Access Compliance Report

Public Rights-of-Way

(Curb Ramps)

Intersection ID: 10023160	Main Street: CHARLOTTE_VIEW_DR	Cross Street: N/A	Location:	N
ADA ID: A08D4FAE6D80	Ramp Type: PerpDiag	Initial Pass/Fail: Fail	Overall Compliance: No	Severity Score: 37.5
Codes/Mitigation Info/Possible Solution		Field Measurements/Component Compliance

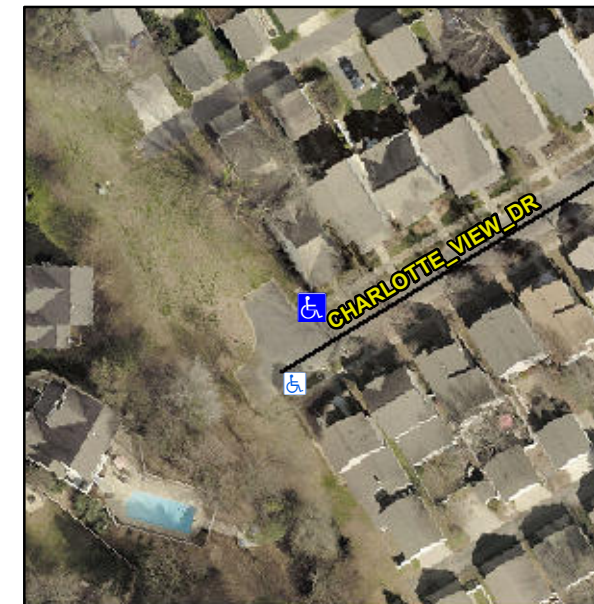
R304.2.2, R304.5.3

Compliance	Description	Data	Compliance	Description	Data
N/A	Ramp Length (in)	60.0	No	Ramp Slope (%)	17.1
Yes	Ramp Width (in)	48.0	No	Ramp XSlope (%)	5.5
N/A	Flare Type LT	N/A	N/A	Flare Type RT	N/A
N/A	Flare Slope LT (%)	N/A	N/A	Flare Slope RT (%)	N/A
N/A	Flare Traversable LT?	N/A	N/A	Flare Traversable RT?	N/A
N/A	Landing Length (in)	N/A	N/A	DWS Provided?	N/A
N/A	Landing Width (in)	N/A	N/A	DWS Contrast?	N/A
N/A	Landing Slope (%)	N/A	N/A	DWS Length (in)	N/A
N/A	Landing X Slope (%)	N/A	N/A	DWS Full Width?	N/A
N/A	Landing Curb? (Y/N)	N/A	N/A	DWS Offset (in)	N/A
N/A	Shared Landing?	N/A			
N/A	Gutter Ponding?	N/A	N/A	Gutter Slope (%)	N/A
N/A	Gutter Lip Ht (in)	N/A	N/A	Gutter X Slope (%)	N/A
N/A	Painted X Walk1?	No	N/A	Painted X Walk2?	No
	X Walk 1 Direction	To W		X Walk 2 Direction	To S
N/A	X Walk 1 Width (in)	N/A	N/A	X Walk 2 Width (in)	N/A
	X Walk 1 Slope (%)	2.6		X Walk 2 Slope (%)	7.9
	X Walk 1 X Slope (%)	5.6		X Walk 2 X Slope (%)	1.3

Remove & Replace Curb Ramp With Two New Directional Ramps or Equivalent.
